### 6.0 EMERGENCY RESPONSE

Figure 60 Peach Bottom 10 and 20 Mile Analysis Areas

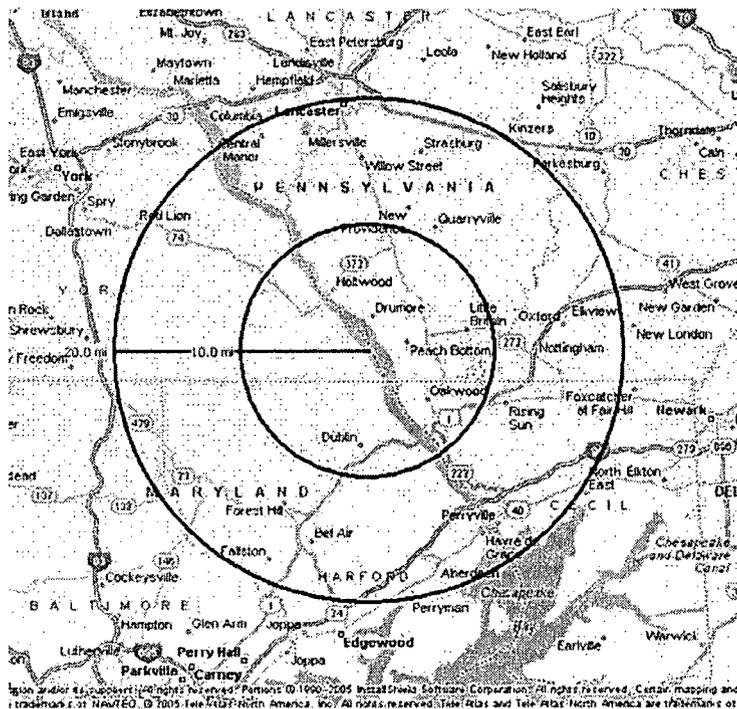
*Is this the place where we should involve that everyone evacuated to 30 miles from the plant before clean air? close door call what?*

Figure 62 Duration of Protective Actions for Unmitigated LTSBO

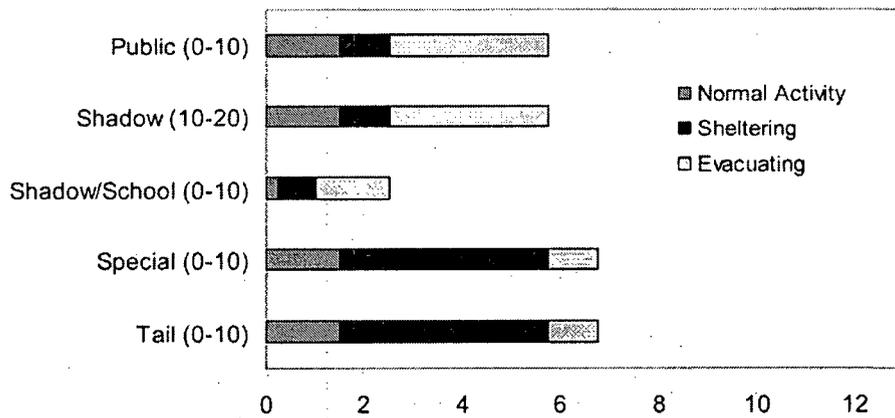
This would show that for this scenario the evacuation is essentially complete before release starts - therefore, all the small vagaries involved that would be large in the discussion are of small consequence

Figure 67 Evacuation Timeline from Peach Bottom for the 10 to 20 Mile Region

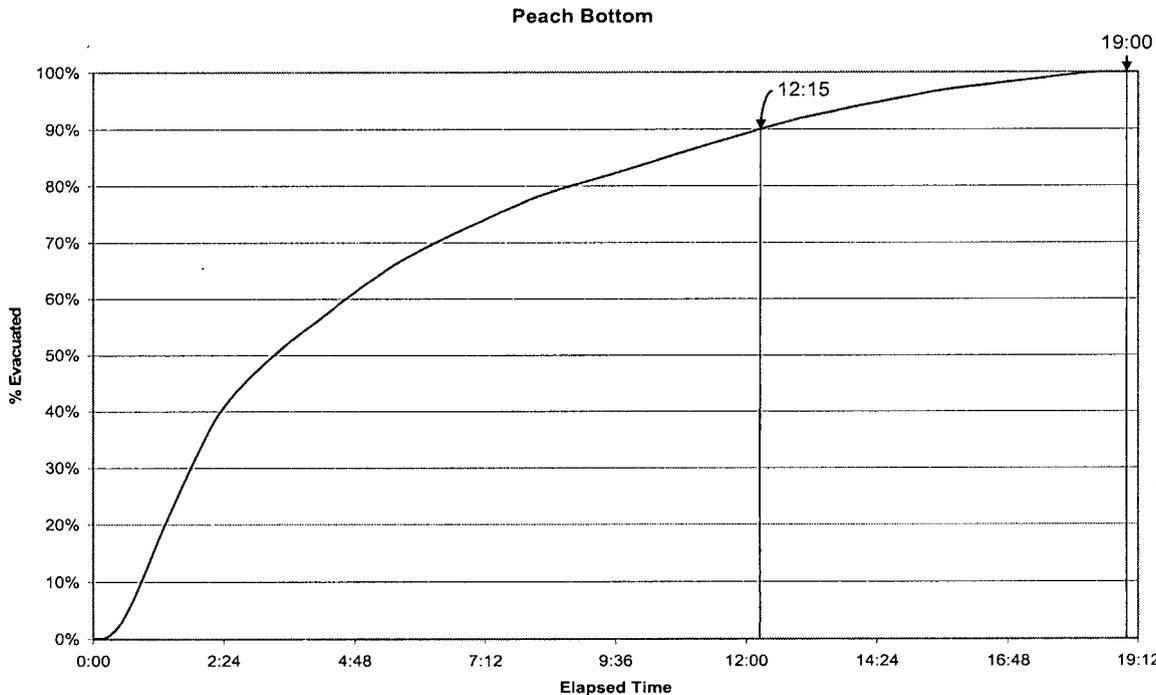
*T=0  
in this  
figure  
is declared  
by  
GE?  
If so  
~ 80%  
have  
evacuated  
before  
plant  
was  
plant -*

**Figure 78 Volume Needed to Fill the Peach Bottom Reactor Building**

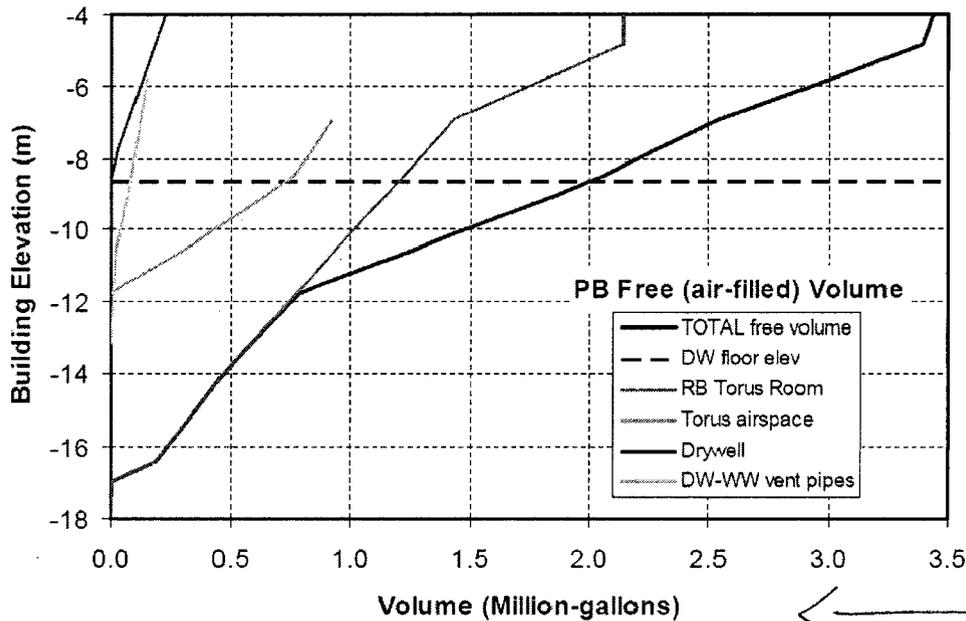
*I would not want to rely on doing it correctly in the first try!*  
133  
*falling the structural supports - in 12 hours to the procedure already thought out?*

*in 12 hours to accept fire truck hoses (which are already here on site) and figured out how to pump in without.*

**Figure 80** Conditional, i.e., assuming accident occurs, mean, latent-cancer-fatality risks from the Peach Bottom unmitigated LTSBO sequence for residents within a circular area of specified radius from the plant. The curves represent four values of dose-truncation level.

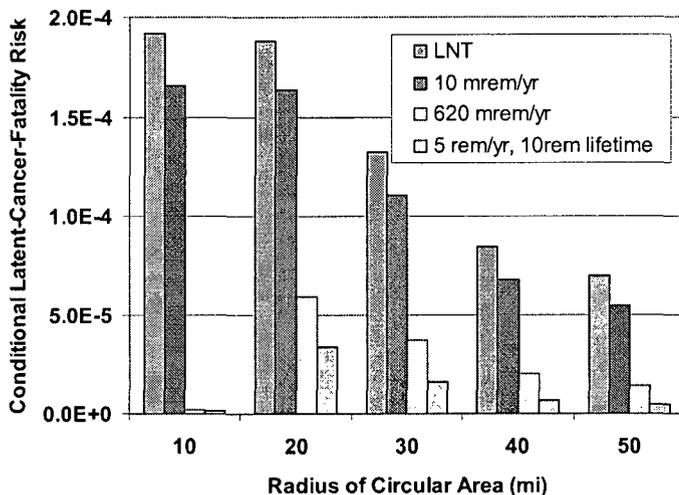
*the CD F for  
This sequence  
is 3x10<sup>-5</sup>/yr*

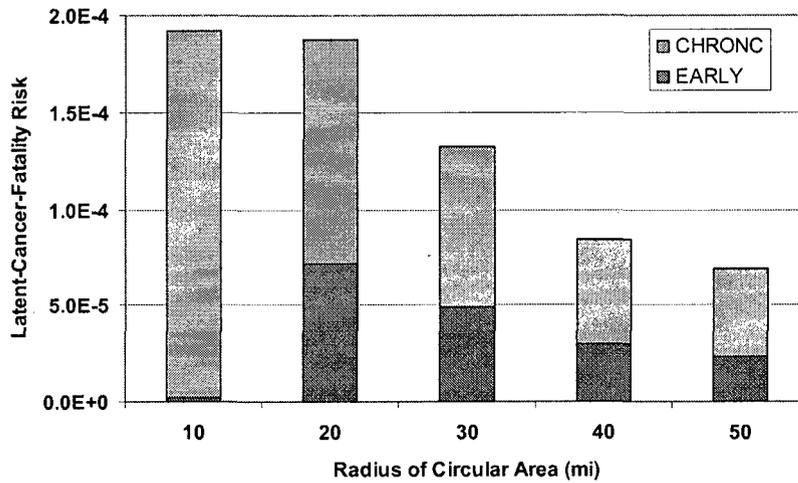
*The CDF for this papers is 3x10<sup>-4</sup> / RB*

**Figure 82** Conditional, i.e., assuming accident occurs, mean, latent-cancer-fatality risks from the Peach Bottom STSBO sequence with RCIC blackstart for residents within a circular area of specified radius from the plant. The curves represent four choices of dose-truncation level.

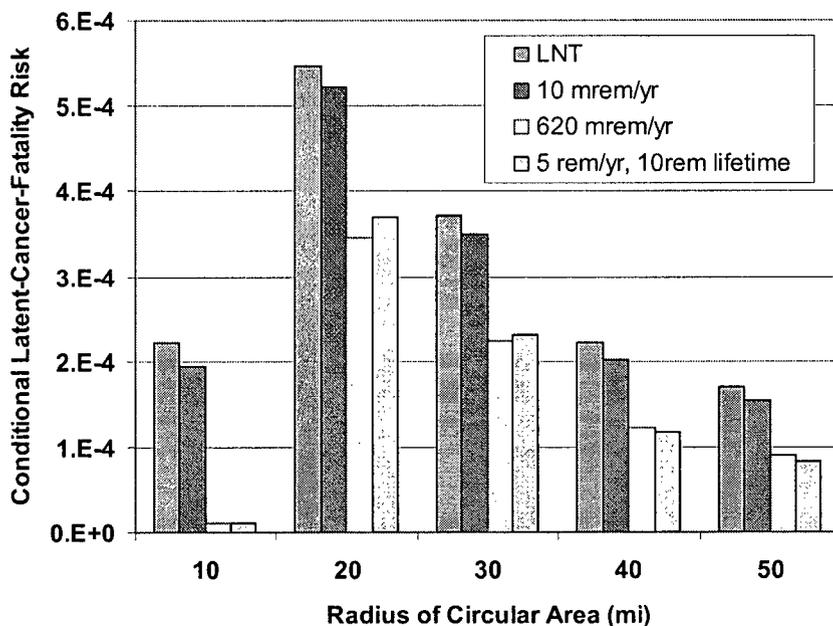
*The CDF  
for this  
scenario  
is 3x10<sup>-7</sup>/yr*

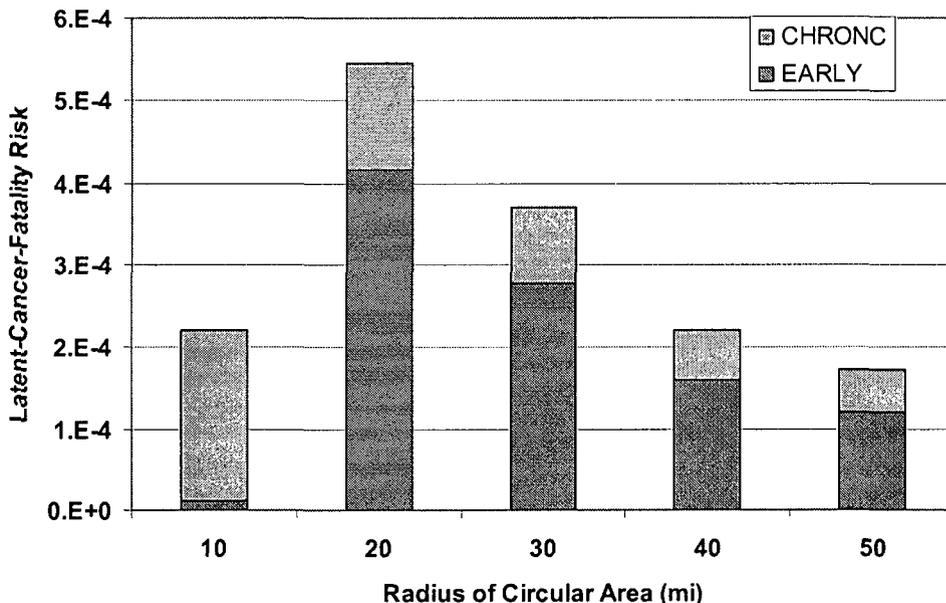
The  
CDFM  
TAS  
scenario  
is 3x<sup>10</sup>-7/  
RY

**Figure 84** Conditional, i.e., assuming accident occurs, mean, latent-cancer-fatality risks from the Peach Bottom unmitigated STSBO sequence for residents within a circular area of specified radius from the plant. The curves represent four choices of dose-truncation level.

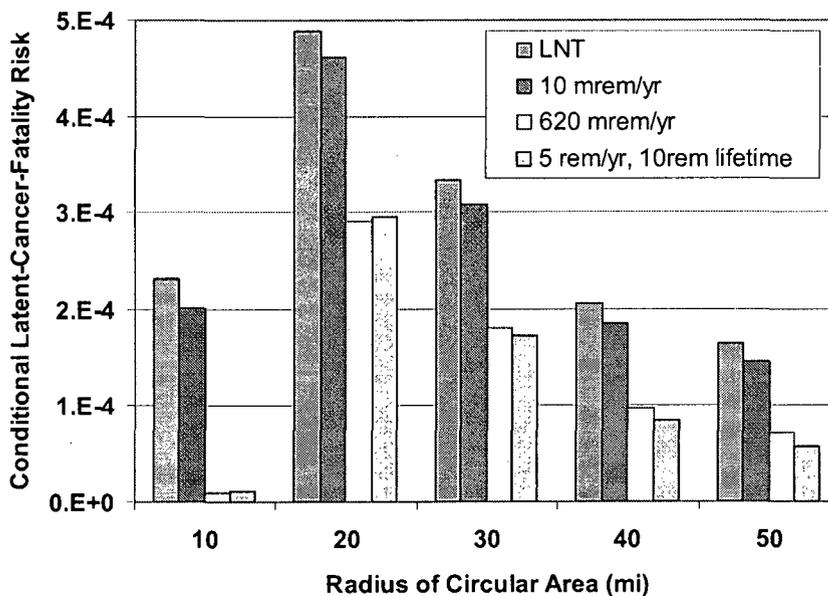
*Handwritten notes:*  
 The CDF for this sequence is  $3 \cdot 10^{-7}/\text{yr}$

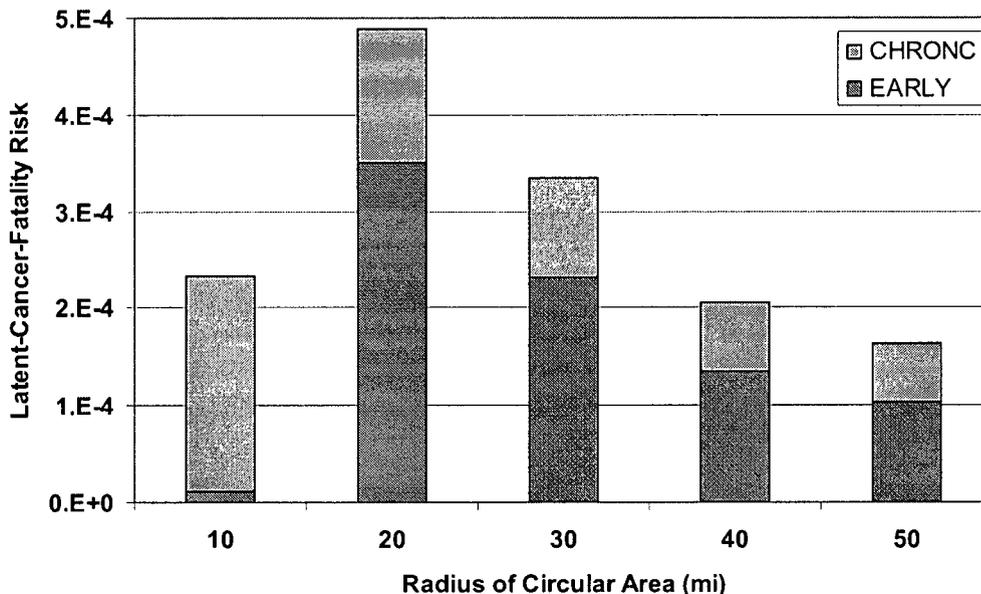
*The CDF  
for the  
sequence  
is  
3x 10<sup>-7</sup>/yr*

**Figure 86** Conditional, i.e., assuming accident occurs, mean, LNT, latent-cancer-fatality risks from the Peach Bottom unmitigated STSBO sequence for residents within a circular area of specified radius from the plant. The columns show the dependence of risk on the size of the evacuation zone.

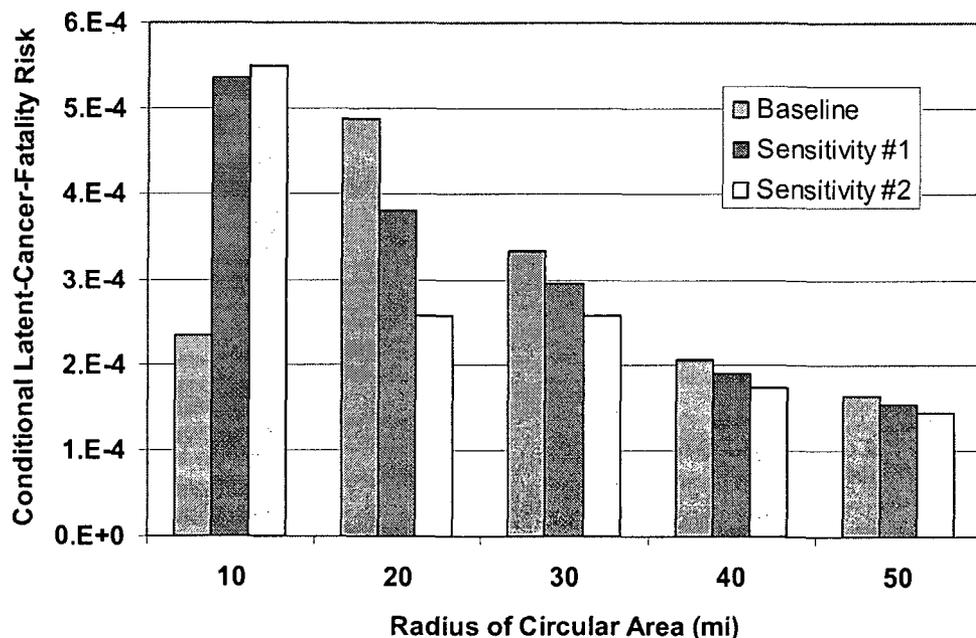
*The CDF for the removal is 3X10<sup>-7</sup>/R<sub>3</sub>*
